# UNITED STATES PATENT AND TRADEMARK OFFICE

**Office Action Summary**

10/509,135

BOSCH ET AL.

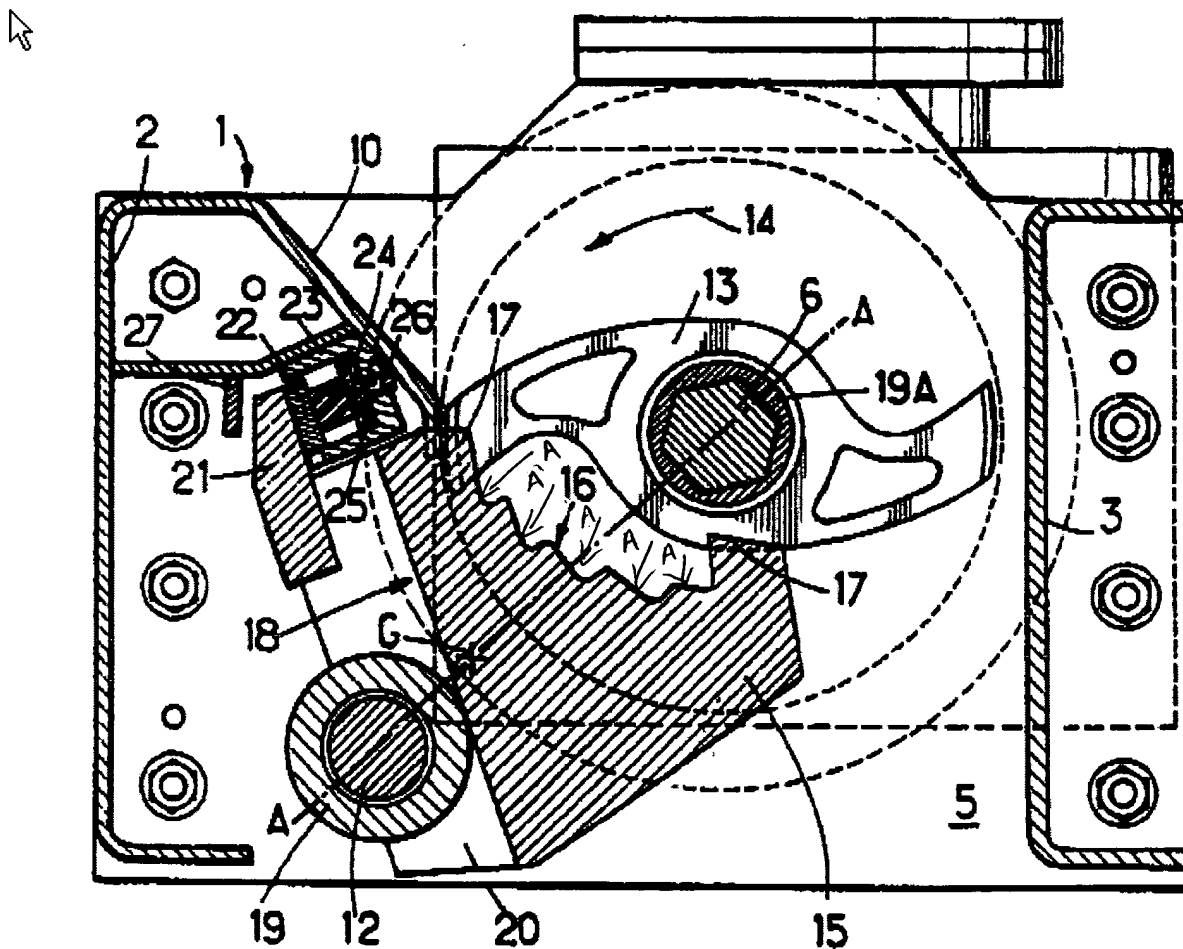
Ballu discloses in Figs 1-4 (also see Figure below wherein the letter A has been added by the examiner), a crushing device for crushing material, with at least one rotor 6 on the circumference of which a plurality of hooks [knives 13] are located, at least one stator [backing knives 15, sleeve 19 and plates 20] on which a plurality of crushing elements A located in a co-operating manner with the hooks are fastened, wherein the stator can be moved in the direction toward the rotor axis and twisted around a stator axis [col 4 line 46 to col 5 line 11] insofar as the applicant has claimed [as the stator is twisted it moves toward or away from the rotar]. Additionally, Ballu discloses that the stator is also movable either axially or transversally [col 3 lines 1-5], the crushing

elements are of a plate-like shape and have at least three lateral edges [Fig 2] and wherein depending on a selected twisting angle of the twistable stator one of the lateral edges [teeth 17] aligned transversally to the material flow direction is involved in the crushing and the twistable stators hydraulically lockable wherein the hydraulic locking of the stators de- activated on reaching a specified pressure load and blocked at a pressure load below the specified pressure load [col 5 line 30 to col 6 line 8].
